GENERAL AVIATION TERMINAL
CITY PROJECT NO. - 17932172

01.03.25 CITY REVIEW COMMENTS

A-623 EXTERIOR SIGNAGE

ENLARGED ELEVATION, AIRSIDE SIGNAGE 5
REFERENCED FROM 1 / A-102 3/8" = 1'-0"

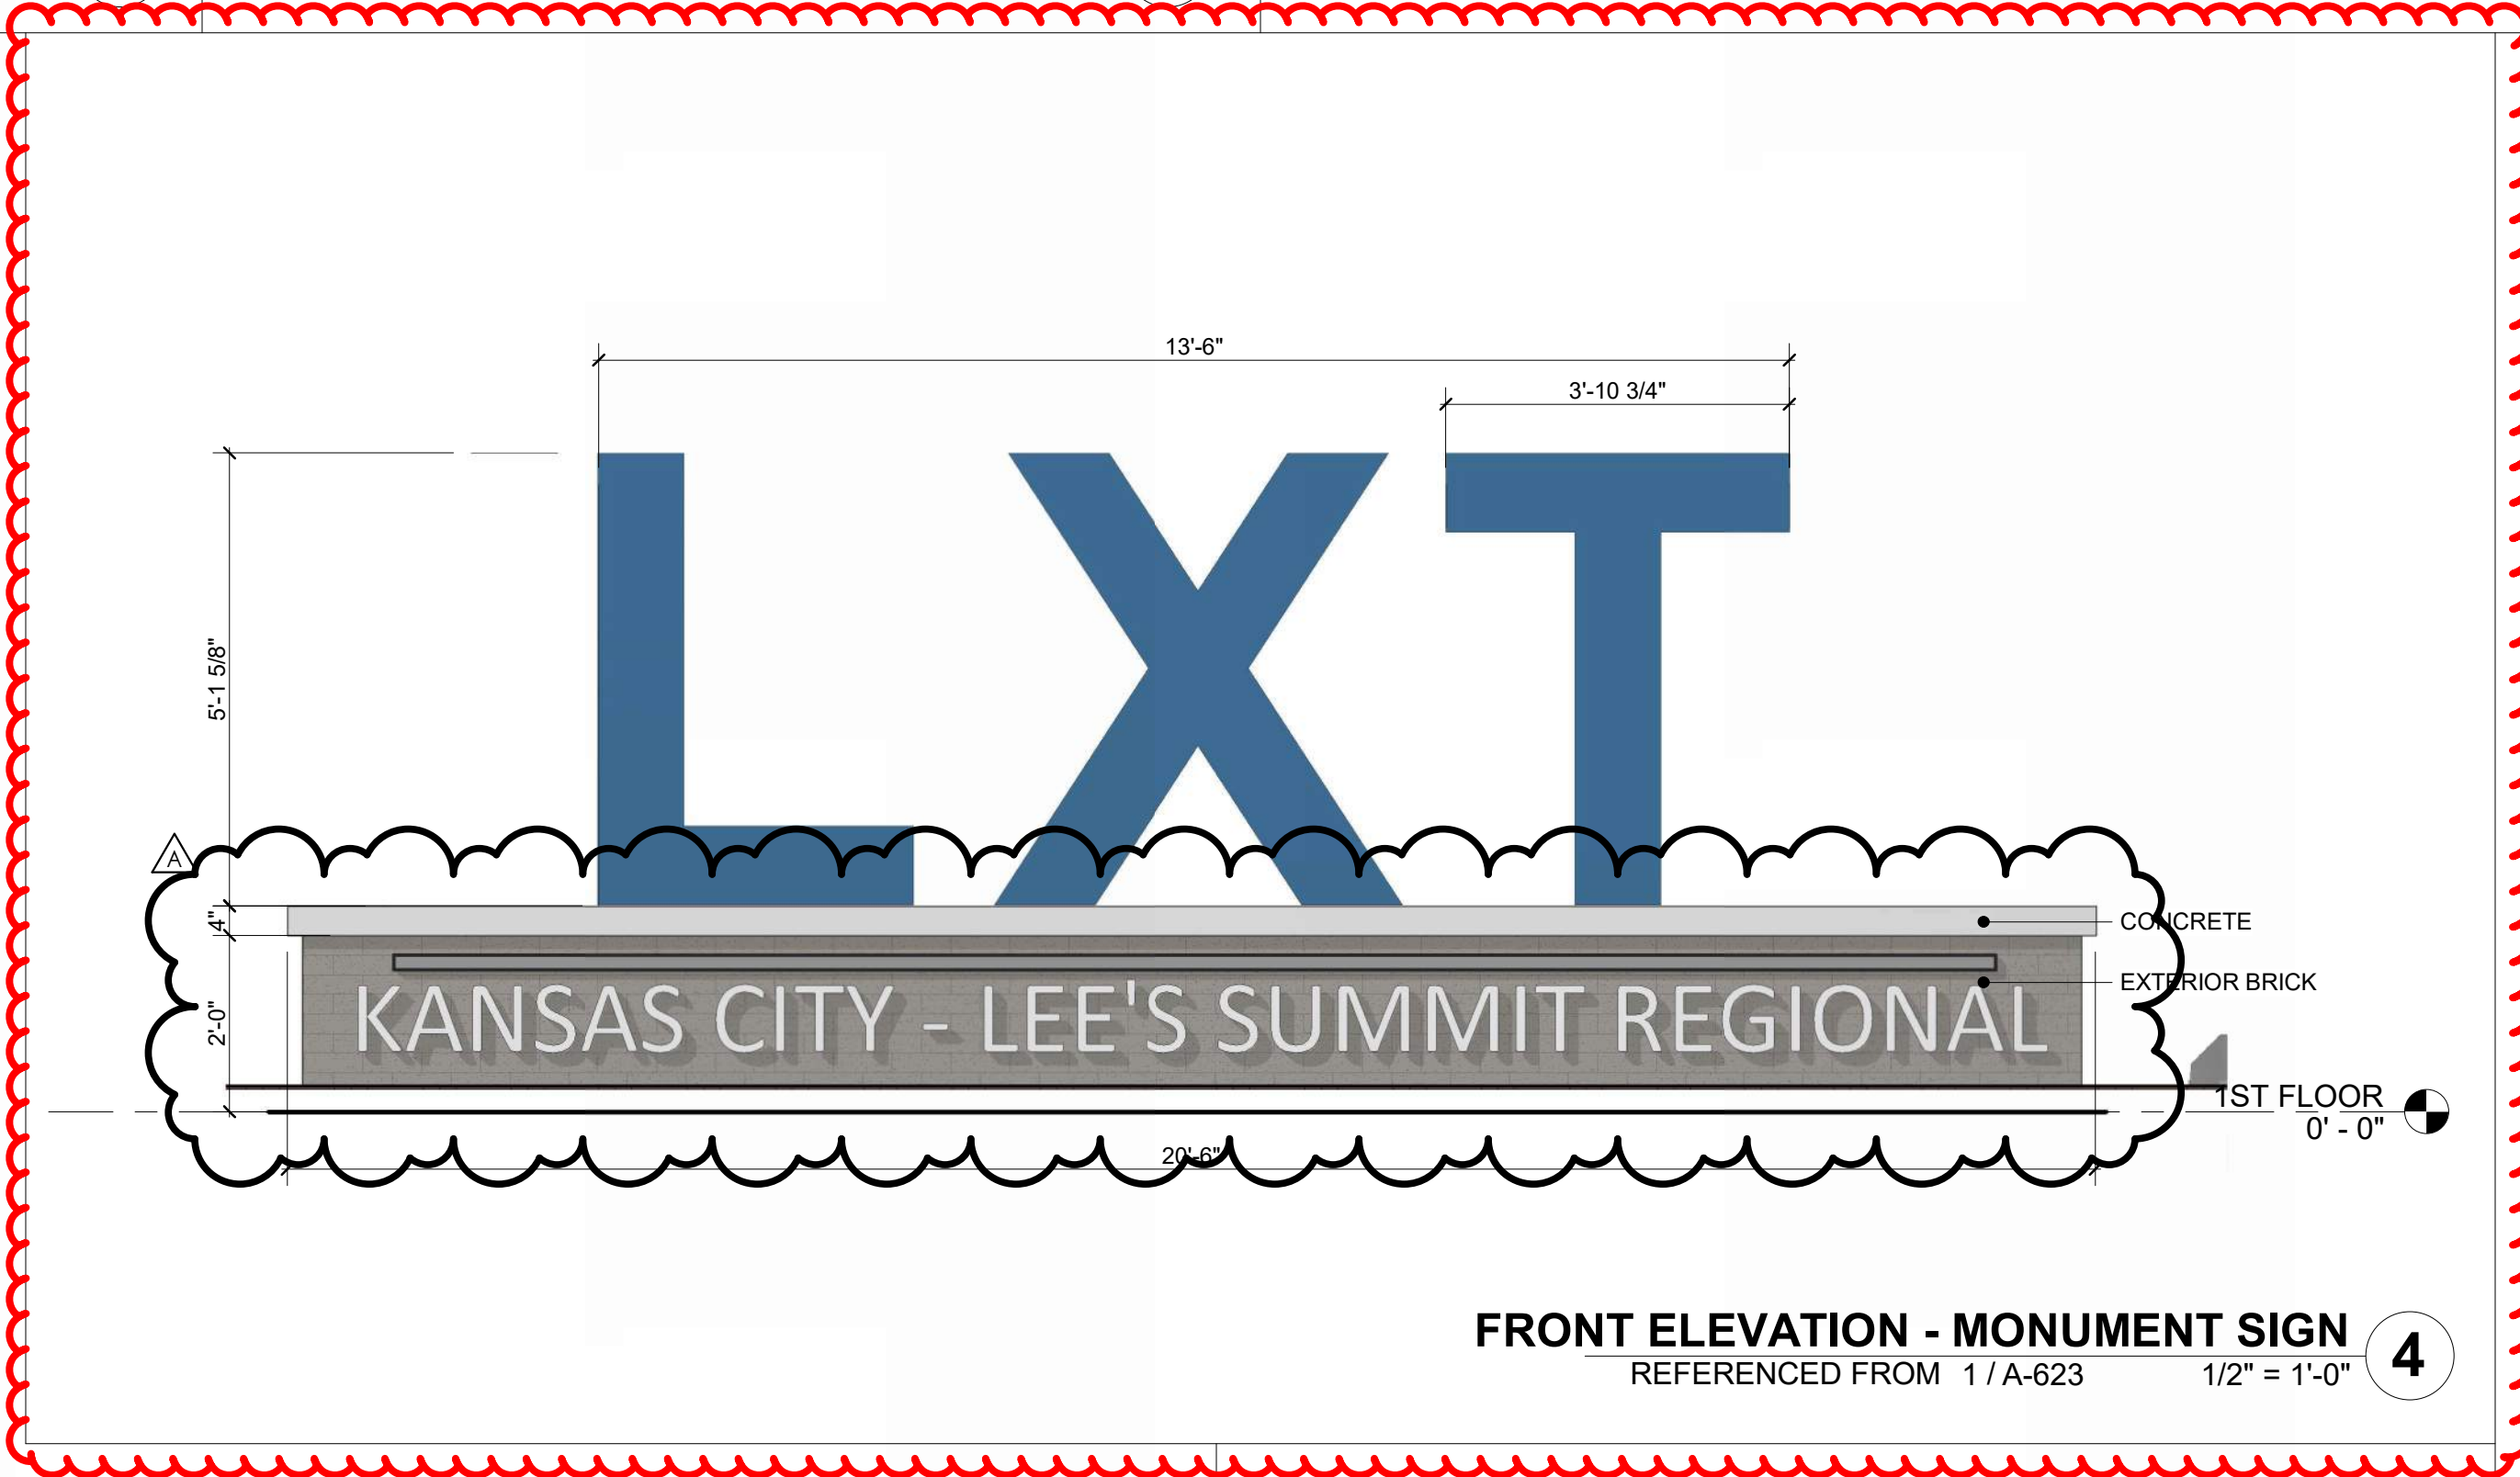
1. **REVISE** on enlarged plan 1- ENLARGED PLAN - MONUMENT SIGN adjust the size and dimensions.
2. **REVISE** on detail 4-FRONT ELEVATION - MONUMENT SIGN the building name to “Kansas City – Lee’s Summit Regional”.
3. **REVISE** on detail 5-ENLARGED ELEVATION, AIRSIDE SIGNAGE the building name to “Kansas City – Lee’s Summit Regional”.
